DOCKET NUMBER
PROPOSED RULE **PR 71**

ENVIRONMENTAL EVALUATION GROUP

Enclosed are the comments of the New Mexico Environmental Evaluation Group on the Major Revision to 10 CFR Part 71. Compatibility with ST-1- the IAEA Transportation Safety Standards.

ADEQUACY OF TRUPACT-I DESIGN FOR TRANSPORTING CONTACT-HANDLED TRANSURANIC WASTES TO WIPP

Figure 10. Filter vent concepts.

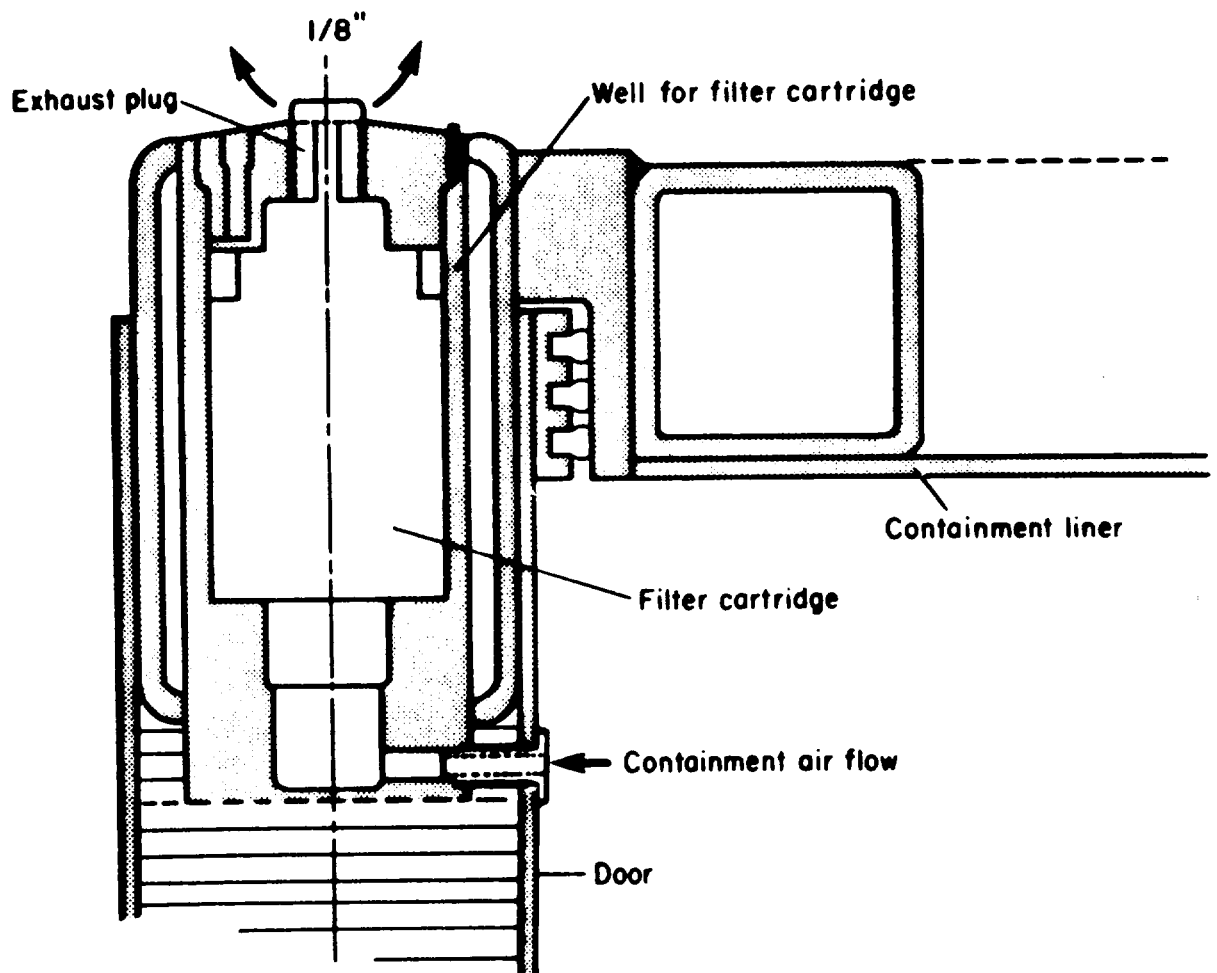
The third option, venting, has received the most attention by DOE. The concept which has been most thoroughly investigated involves venting the waste packages through rugged high efficiency filters or permeable gaskets and vent clips so that gases are released. Particulates are supposed to be retained in the containers even under severe transport conditions. Figure 10 (a) illustrates the small filter (RFP bung filter) being considered by DOE for Type A packages, and 10 (b) the filter design which has been proposed for the TRUPACT (if it is vented). The prime consideration is whether venting will provide the needed control of hydrogen concentrations in Type A packages and the Type B TRUPACT under the actual transport conditions of the waste forms and TRU concentrations anticipated

Figure 11. Schematic of drums inside TRUPACT.

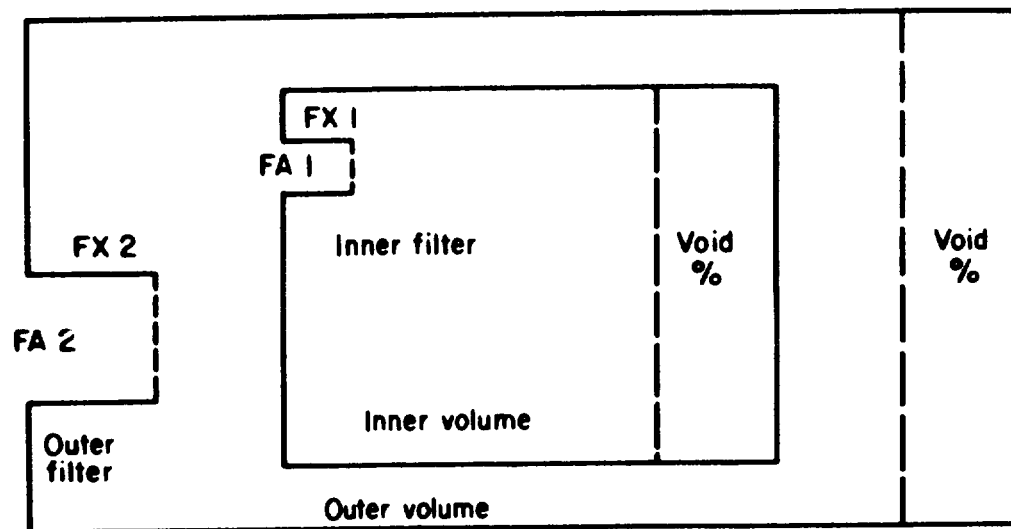
The TRUPACT container geometry is shown in Figure 11. The inner volume represents the Type A packages containing TRU waste. In the case of a fully loaded TRUPACT with 36 55-gallon drums, the inner volume represents one of these drums and the outer volume represents 1/36th of the TRUPACT void when loaded. Each volume is assumed to have a filtered vent, with characteristic thickness and area. Vents can be modeled as sealed as well as

Figure 14. Vented TRUPACT with 36 drums (20 Ci/drum).

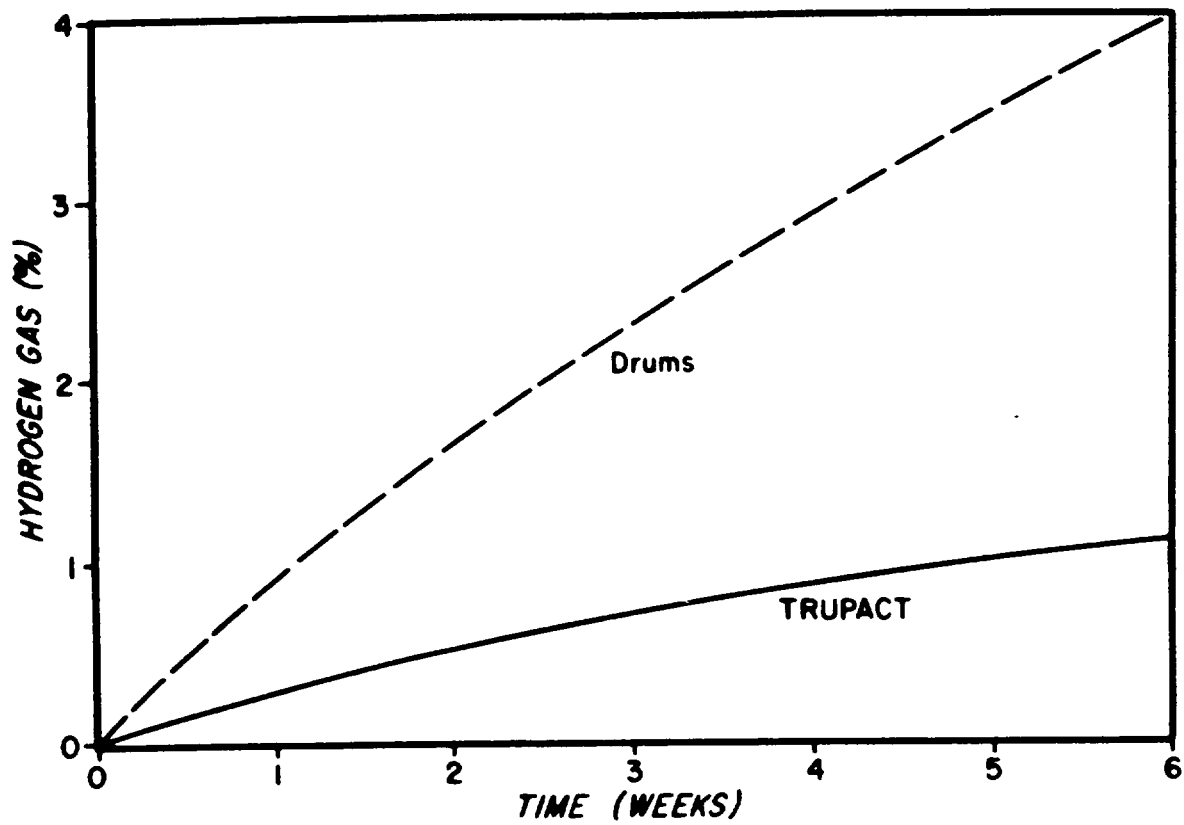
By modeling, we have attempted to examine the predicted efficacy of venting. If the case of dry combustibles where G (hydrogen) = 2.1 is extended to the maximum controllable loading by the Clements and Kudera method, the allowable loading would be 20 curies and the 4% limit would be exceeded in about 3 weeks. Furthermore, if 36 of these drums were loaded into a vented TRUPACT, concentrations would reach 4% hydrogen in 6 weeks. (See Figure 14).

results, we conclude that venting of the Type A and Type B (TRUPACT) waste packages to achieve hydrogen control is not likely to result in the desired effect for a significant portion of the present defense TRU inventory and thus should not be relied upon as a control mechanism, particularly if a relatively inexpensive and effective alternative control practice is available.

Figure 16. Effects of getter on hydrogen concentration in drums.

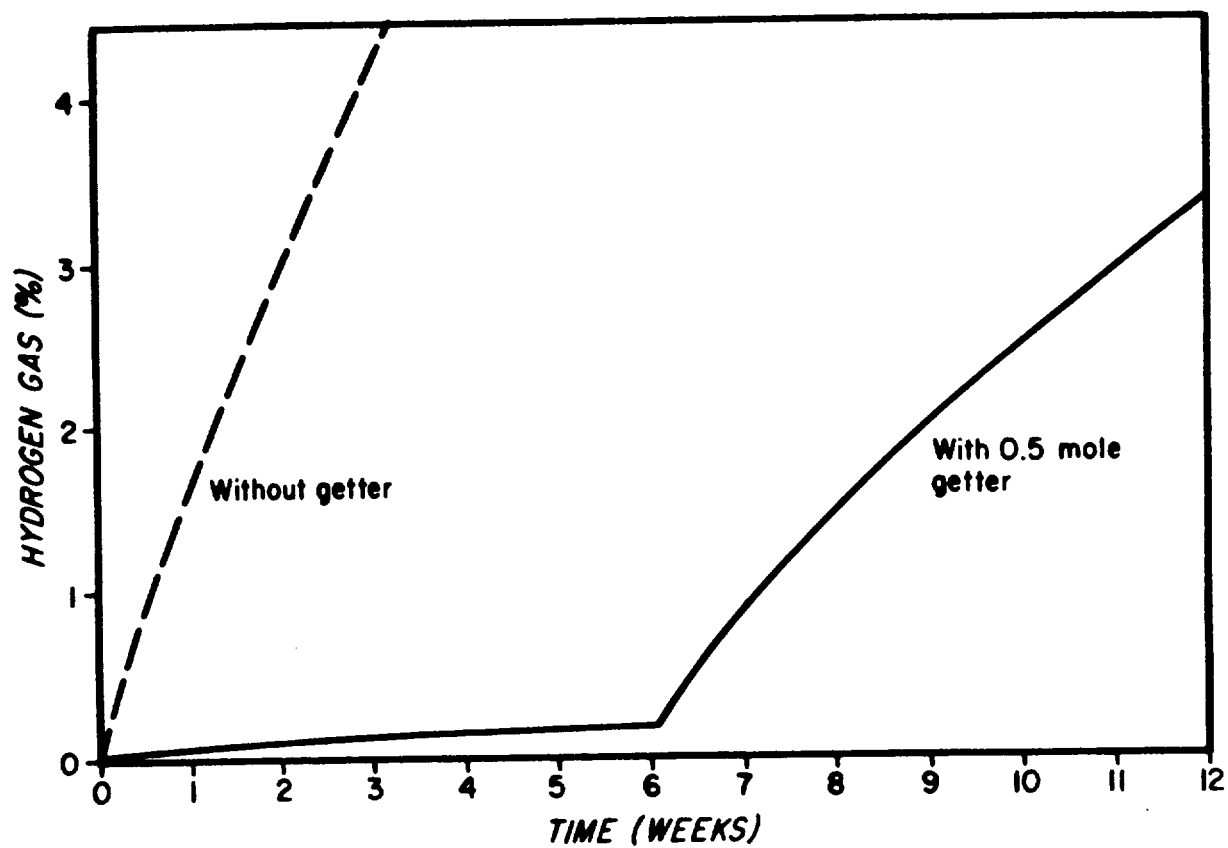
If the removal process is limited primarily by diffusion of hydrogen to the active surface, effective control can be anticipated by placing a hydrogen getter (Fig 15) in the drum. It may be possible to spray getter material in sufficient quantity on the inner surface of Type A packages to effectively control hydrogen for the handling and shipping period. A computer model simulation of such a process is shown in Figure 16. A simple representation of the removal by gettering was assumed with only a limited number of sites available (0.5 hydrogen moles equivalent). Without the use of getters, a

flammable level of hydrogen is reached in less than 3 weeks. However, with getters, an additional 3 weeks of very low hydrogen concentrations are realized before the getter is consumed, and several more weeks during which ingrowing hydrogen concentrations are still below four percent.
